# Access Compliance Report

## Public Rights-of-Way

Intersection ID: 25958	Main Street: KINGFISHER_DR	Cross Street: PARK_RD	Location: NW
ADA ID: 64D9EC044833	Ramp Type: PerpDiag	Initial Pass/Fail: Fail	Overall Compliance: No
Codes/Mitigation Info/Possible Solution		Field Measurements/Component Compliance	
Severity Score: 58.75

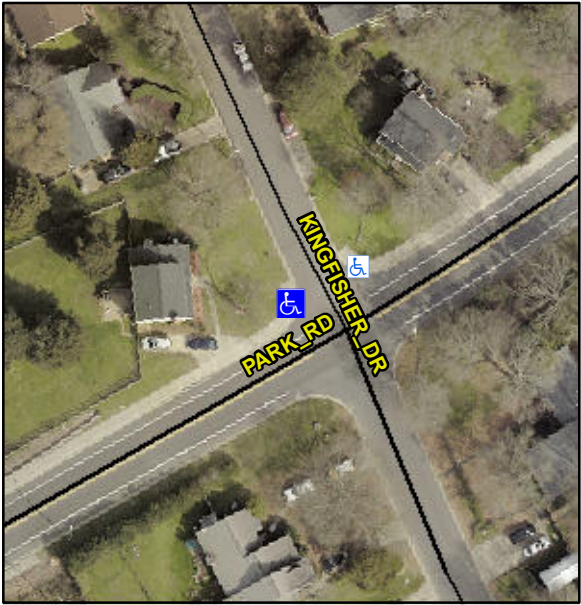
Possible Solutions:		Compliance	Description	Data	Compliance	Description	Data
	Remove & Replace Curb Ramp With Two New Directional Ramps or Equivalent.		N/A	Ramp Length (in)	69.0	No	Ramp Slope (%)	13.2
<p>Surveyor Notes:</p> <p>N/A</p> <p>PROW/ADA:</p> <p>R304.5.1, R304.2.2, R304.5.3</p>			No	Ramp Width (in)	46.0	No	Ramp XSlope (%)	7.4
			N/A	Flare Type LT	N/A	N/A	Flare Type RT	N/A
<p>Street 1 Name</p> <p>Stop Condition-Street 2</p> <p>Street 2 Name</p> <p>Stop Condition-Street 1</p>			N/A	Flare Slope LT (%)	N/A	N/A	Flare Slope RT (%)	N/A
			N/A	Flare Traversable LT?	N/A	N/A	Flare Traversable RT?	N/A
<p>Total Cost:</p> <p>\$ 3200.00</p>			N/A	Landing Length (in)	N/A	N/A	DWS Provided?	N/A
			N/A	Landing Width (in)	N/A	N/A	DWS Contrast?	N/A
			N/A	Landing Slope (%)	N/A	N/A	DWS Length (in)	N/A
			N/A	Landing X Slope (%)	N/A	N/A	DWS Full Width?	N/A
			N/A	Landing Curb? (Y/N)	N/A	N/A	DWS Offset (in)	N/A
